MACHINE SERVICE BULLETIN NO. 358

SUBJECT: Reversals
LA-5 and LA-6 Models

DATE: July 19, 1940

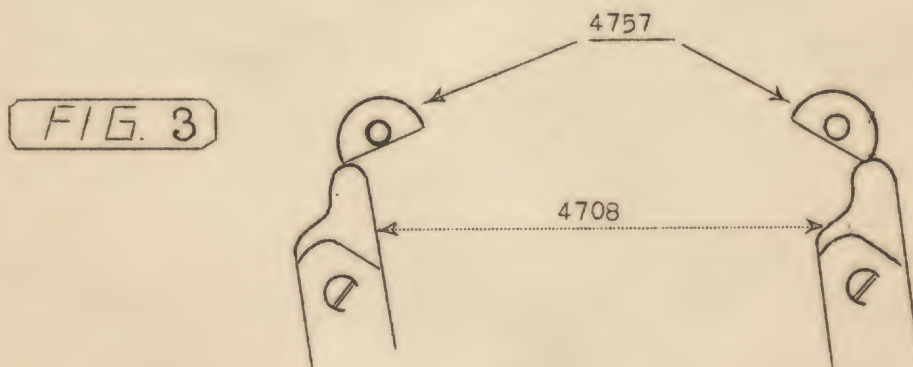
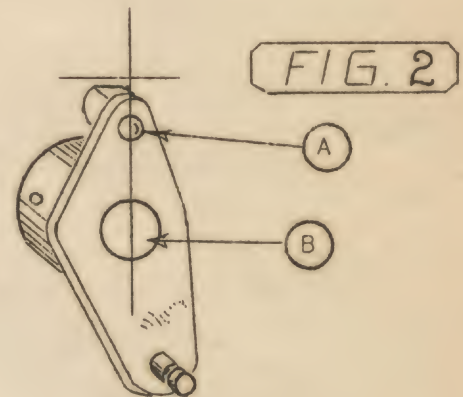
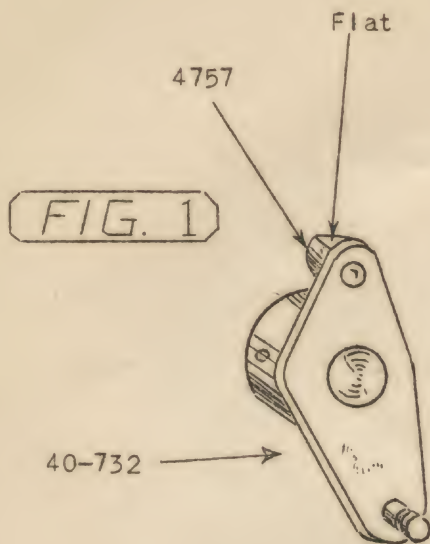
The 4757 stud on the 40-732 and 41-732 crank arm of the carry shaft has a flat side which serves the purpose of retarding the clutch yoke until the proper time for it to move its position from plus to minus or vice versa. See Fig. 1.

The two edges of this flat side move the clutch yoke into the plus or minus position according to the direction the machine starts to cycle. As the 40-732 or 41-732 turns, the edge of the flat side will contact the center point of the top of the 4708 blank and cause the yoke to move into the position desired (provided the 4708 is correctly adjusted) and the flat of the 4757 stud will prevent movement of the yoke in the wrong direction if it should receive a rebound from some source. See Figures 3 and 4.

If reversal trouble is encountered, inspect the 40-732 crank arm to determine if the flat of the 4757 stud is located at a right angle to a line drawn through the center of shaft (B) and rivet (A). See Figure 2. If for some reason the flat is positioned otherwise, remove the 40-732 or 41-732 and while held in a vise, turn the stud to the proper position with pliers, after which retighten the rivet or replace the 40-732 or 41-732 with another.
